ANN ARBOR HISTORIC DISTRICT COMMISSION**Staff Report****ADDRESS:** 336 S. Division Street, Application Number HDC22-1147**DISTRICT:** Old Fourth Ward Historic District**REPORT DATE:** August 11, 2022**REPORT PREPARED BY:** Jill Thacher, Historic Preservation Coordinator**REVIEW COMMITTEE DATE:** August 8, 2022

APPLICATION: The applicant seeks HDC approval to construct two basement egress windows with landscape timber wells on the rear elevation of the house.

AREA WELL DETAIL

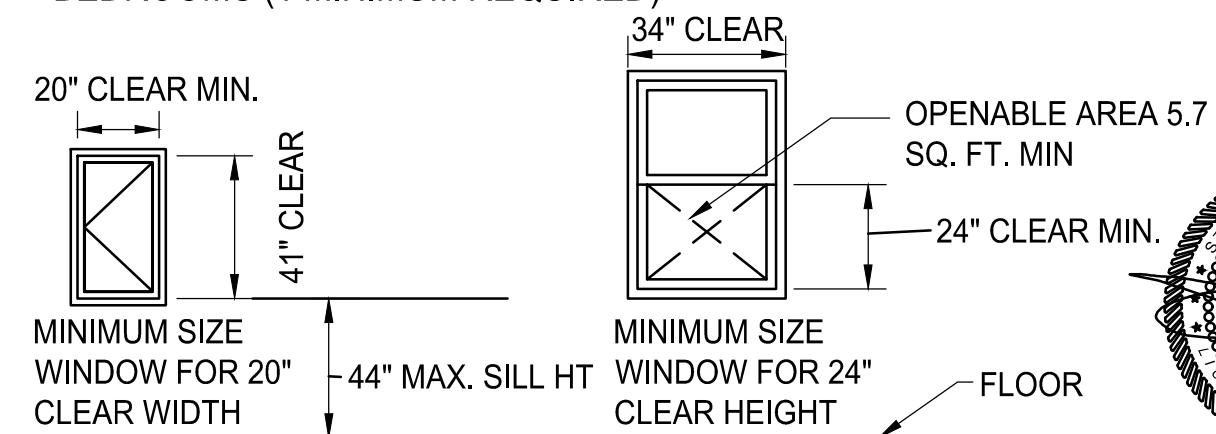
- 1) This house appears to have originally been 22' square, which could have been described as a four-square with craftsman detailing, with a one-story rear wing. There are no windows currently on this basement wall.
- 2) The window wells are drawn as 40" x 56" with a 36" x 36" clear area inside as required by code. Wells are built of 4" landscape timbers, with a drain and egress ladder. Casement windows are 36" wide by 48" tall and are Andersen 400 series vinyl-clad wood. The tops of the windows will be 6" or less above grade, per the applicant.
- 3) The location is appropriate, on the back of the house and not visible from the street. The proposed materials are appropriate, as are the window and well sizes. Staff recommends approval of the application.

I move that the Commission issue a certificate of appropriateness for the application at 336 S Division Street, a contributing property in the Old Fourth Ward Historic District, to construct two timber egress window wells with clad wood windows on the rear elevation, as proposed. The work is compatible in exterior design, arrangement, materials, and relationship to the house and the surrounding area and meets *The Secretary of the Interior's Standards for Rehabilitation and Guidelines for Rehabilitating Historic Buildings*, in particular standards 2, 9, and 10 and the guidelines for building site, windows, and health and safety, as well as the *Ann Arbor Historic District Design Guidelines*.
